Docket Item # 3
BAR CASE #2011-0245

BAR Meeting
September 21, 2011

ISSUE: Certificate of Appropriateness
APPLICANT: Allen & Rebecca Weh by Mehmet Elbirlik
LOCATION: 400 N Union Street
ZONE: RM / Residential

Figure 5: Window being reduced on N Union façade (note ghost marks from when this window was a door).

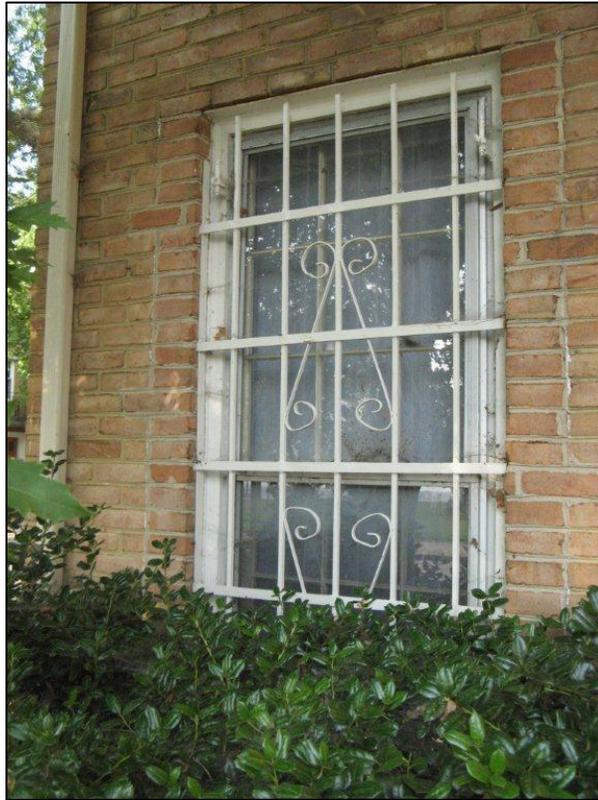
The applicant proposes to reduce the size of the first floor window on both the N Union (front) and Princess Street (side) façades for both security concerns and the installation of a dumbwaiter on the interior. Both window openings will be reduced to 24” by 42.” Brick will be toothed in around the windows to match the existing brickwork and new concrete sills will be used that will also match the existing. The window on the N Union façade will remain centered with the upper windows and the window on the Princess Street façade will be shifted to the right so that it aligns with the upper windows, an improvement to this façade. The iron bars on these two windows will be removed.

While this is a reasonable utilitarian alteration done to meet interior needs, Staff feels a less invasive alternative to resizing the windows would be to re-install shutters on the two windows and simply close the shutters. This would be a more easily reversible alternative and would not destroy any original building fabric.

The proposed diminutive windows are aligned with the windows above and are a similar multi-pane style. However, they do not provide much architectural interest for pedestrians on the first floor level of this large townhouse facing Founder’s Park. Another alternative would be to install an octagonal feature window with a brick rowlock surround that would help visually balance the entry door (on Princess) and the garage door (on N Union).

1. That the window replacements comply with the *Alexandria Replacement Window Performance Specifications*;
2. That any rotted window trim is replaced in kind;
3. That the rear patio door replacement comply with the *Alexandria Replacement Window Performance Specifications*.
4. That the two windows on the front and side facades be feature windows to provide more architectural interest at the pedestrian level.

Figure 7: Front and rear elevation changes.

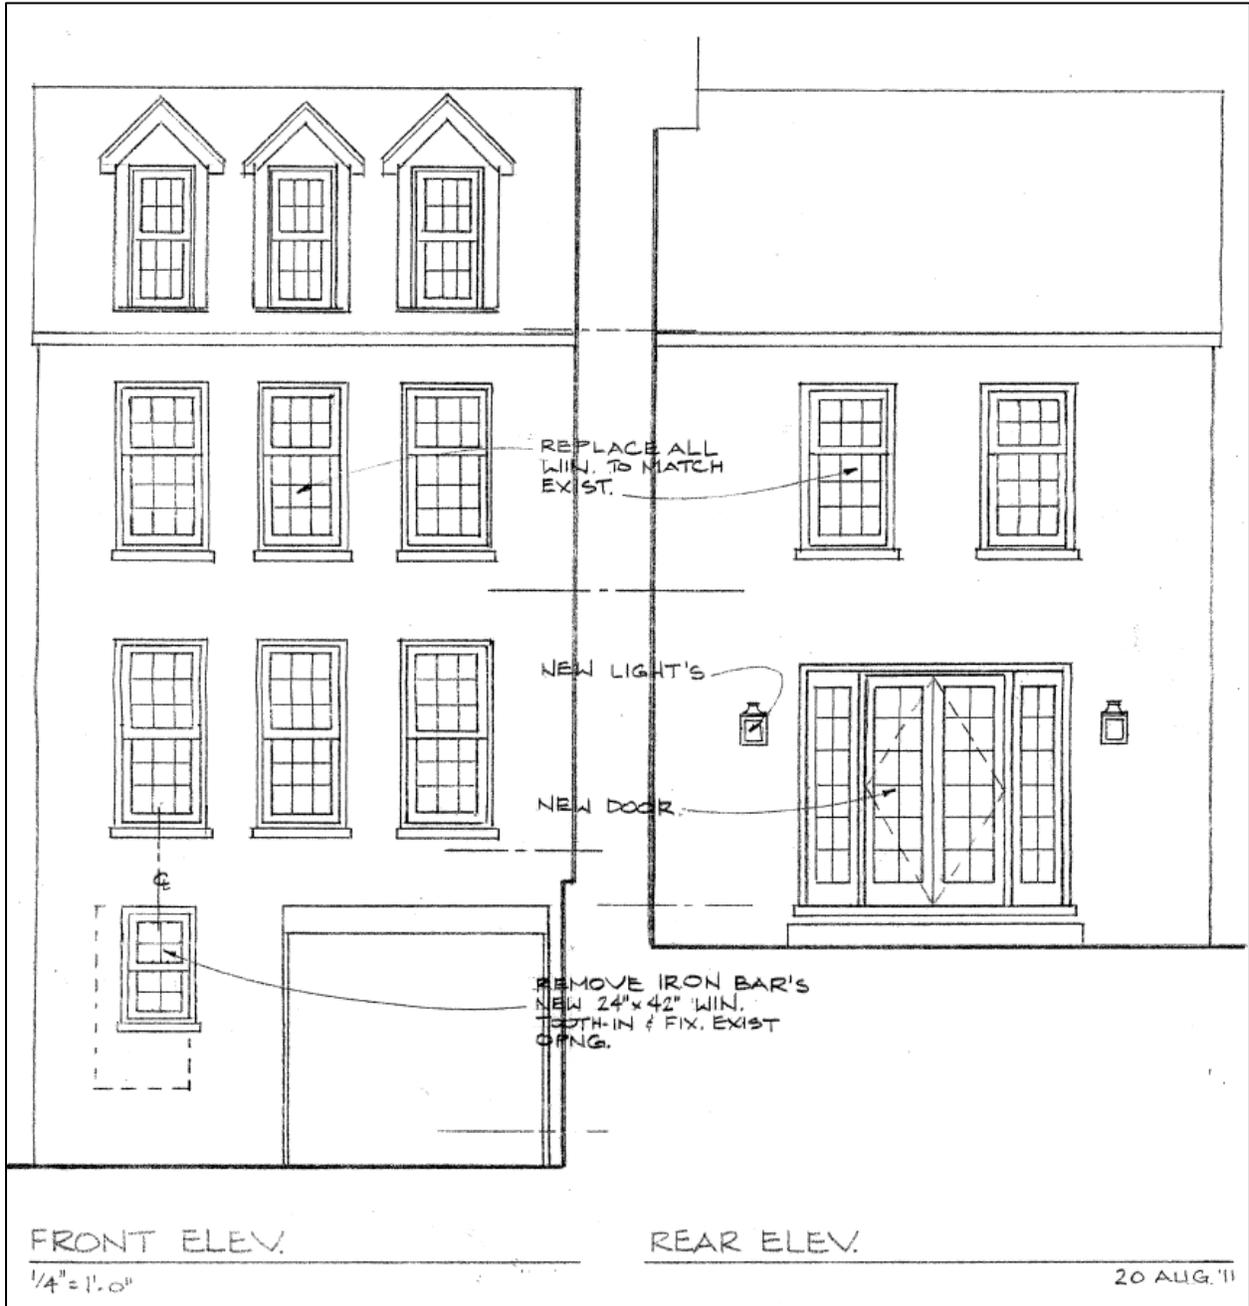
The existing patio door is a solid glass, triple sliding door. It is completely lacking in style on an already blank rear façade. Staff feels that the new design of the French doors with side-lights is appropriate in detail for this townhouse and much more visually appealing. The materials comply with the *Window Policy* and match the proposed window replacements, providing a consistent look on all three facades. Staff recommends approval of the rear patio door

Figure 8: Side elevation changes.

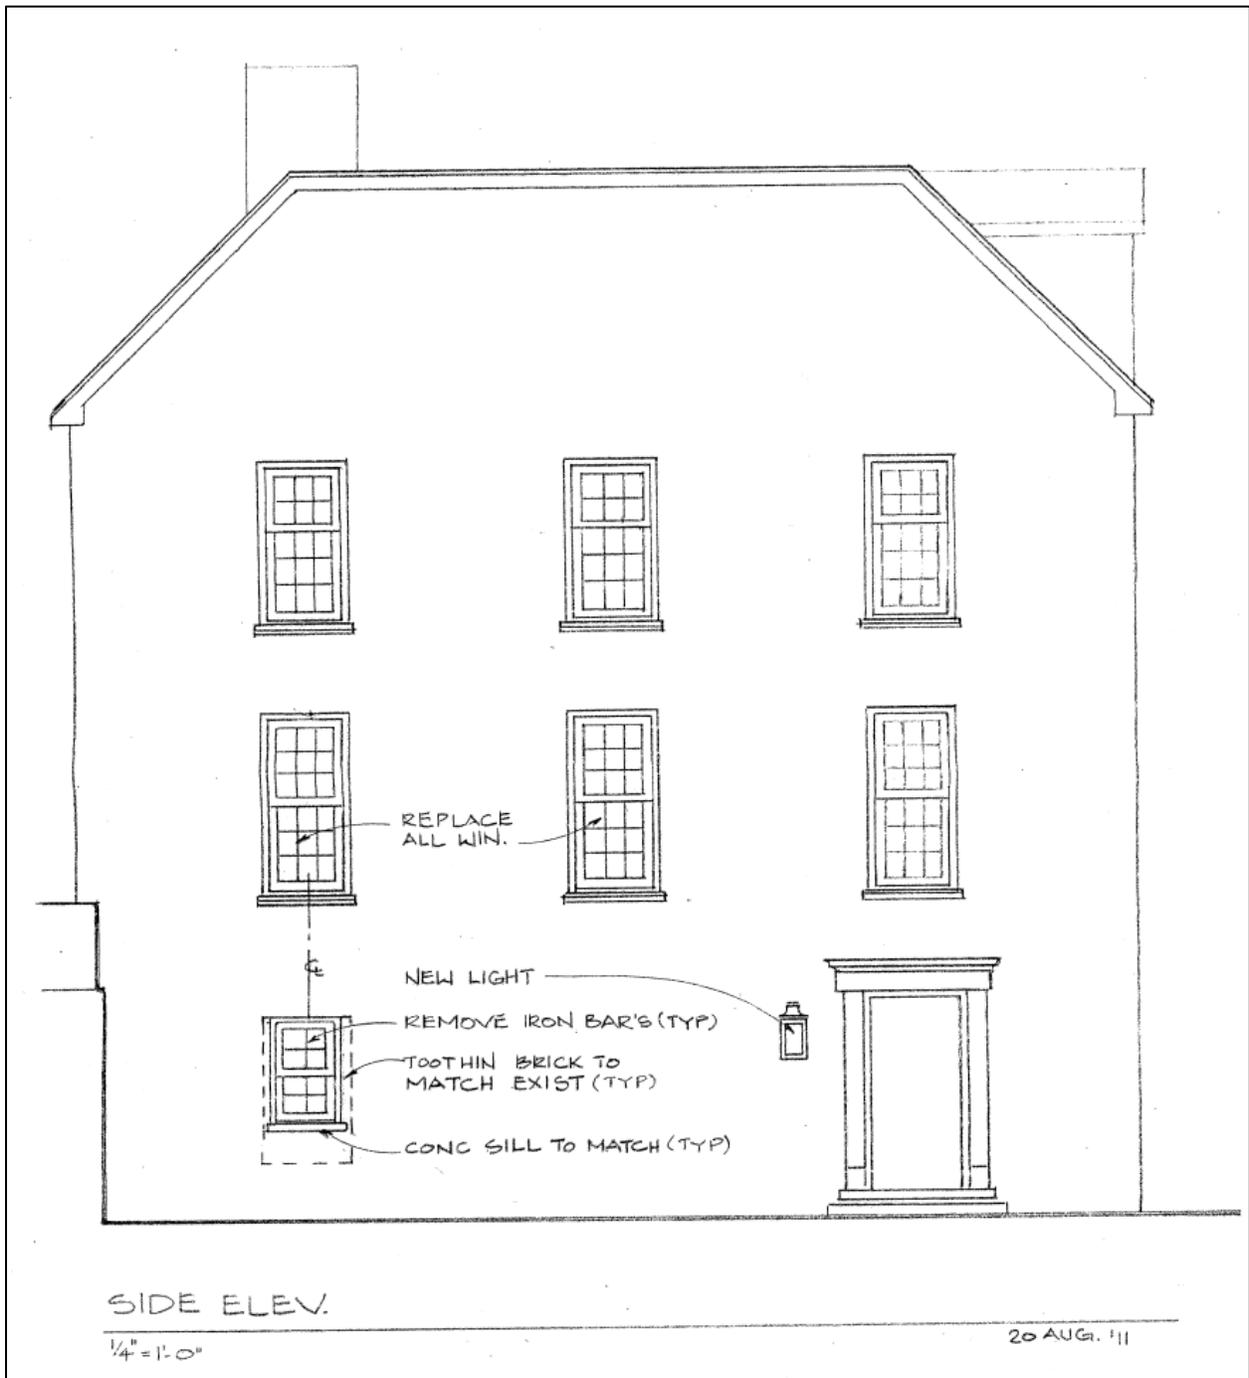
Staff feels that there are better alternatives for these highly public facades and strongly encourages windows which provide more architectural interest than the proposed alterations.

Figure 9: Proposed lighting

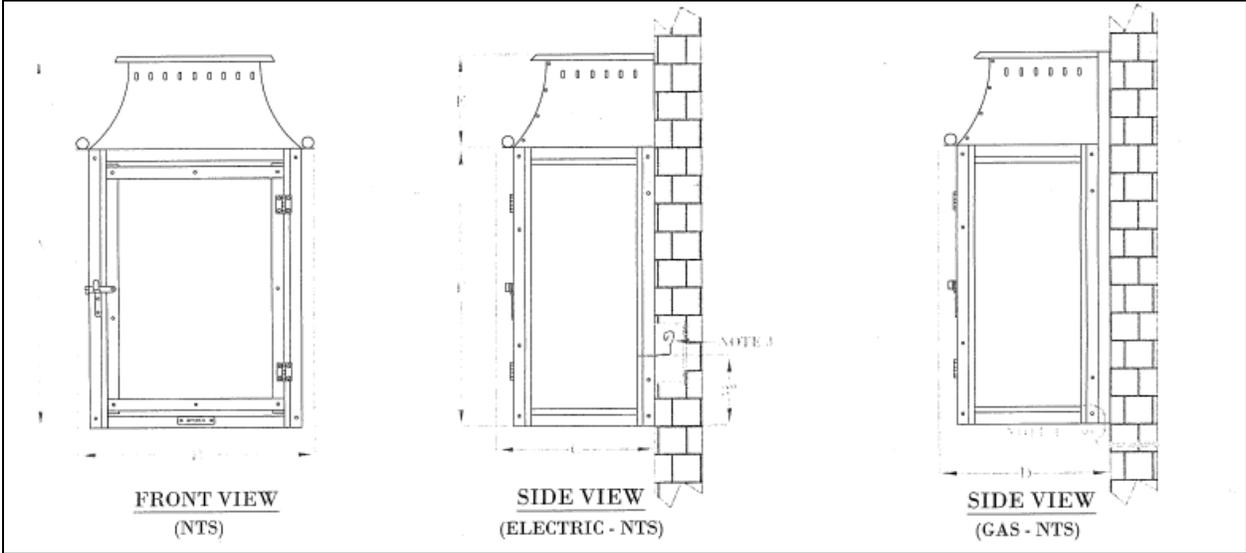
The proposed flush mounted, exterior electric lights with a copper finish do not obscure or wash out any character defining features and are compatible in material, design, and scale to this large 1970s Colonial Revival townhouse. The exterior lighting could have been approved administratively due to the following language in the *Minor Architectural Elements Policy* that states that “new light fixtures may be approved administratively provided that they are architecturally and historically appropriate in design and material,” but again, the applicant chose to keep the entire application together to provide the Board with an overall context for the proposed project. Staff therefore, recommends approval of the proposed exterior lighting.
